(11)
+ 3 attachments

Sunrise Mine Project: Modification 4

Runoff from Bullock Creek Catchment During Storm Events

– Review of Proposed Stormwater Diversion Channels & Tailings Storage Facility

Table 1: Local Records of Major Rainfall Events

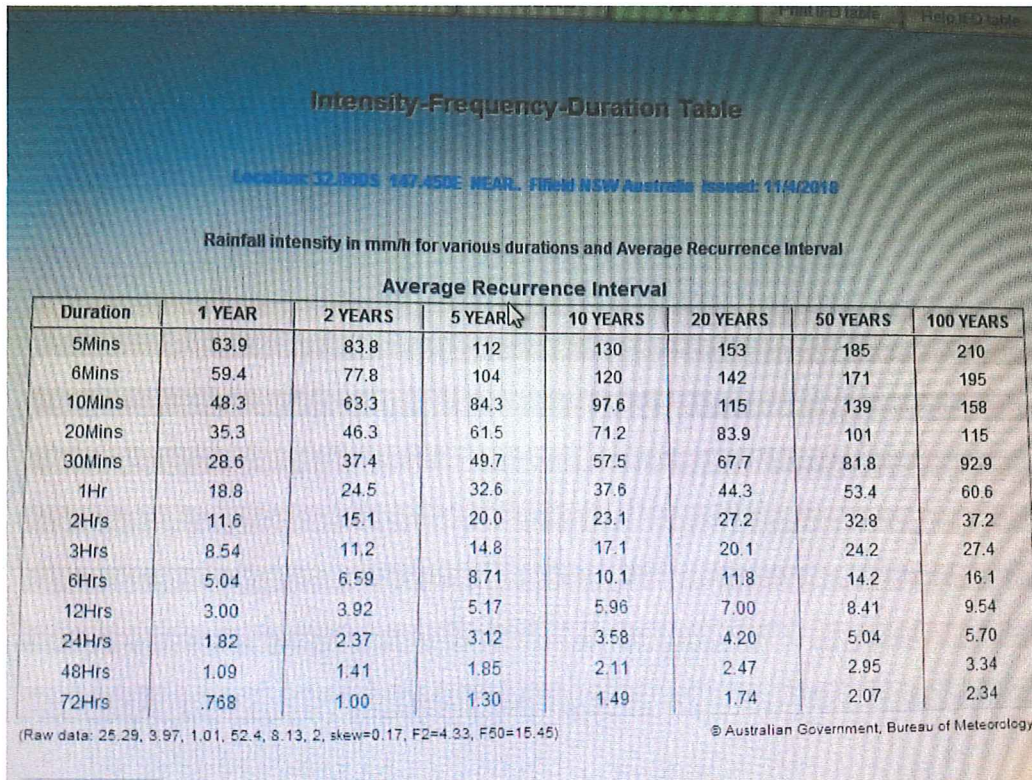
The local rainfall data to which we refer is listed in Table 1 below. The data is sourced from the local properties 'Sunrise' (now owned by the proponent) and the adjoining neighbour Mr D Ward on 'Berrilee'. We have the original rainfall charts if you wish to seek verification.

Please also note that in the three weeks preceding the 8 Nov 2005 storm 'Sunrise' received 62 mm of rain and 'Berrilee' 68mm, so the catchment was already quite wet. That rain was in addition to a wet five month period from June that year.

'Sunrise' and 'Berrilee' are approx. 8 kms apart. Note the storm cell on 8 Nov 2005 tracked east to Trundle, which recorded 200mm.

The BOM met station at Murrumbogie (#050028), used by the proponent for its calculations, is approximately 17 km south-east of the mine site and received 120mm from the 8 Nov 2005 storm.
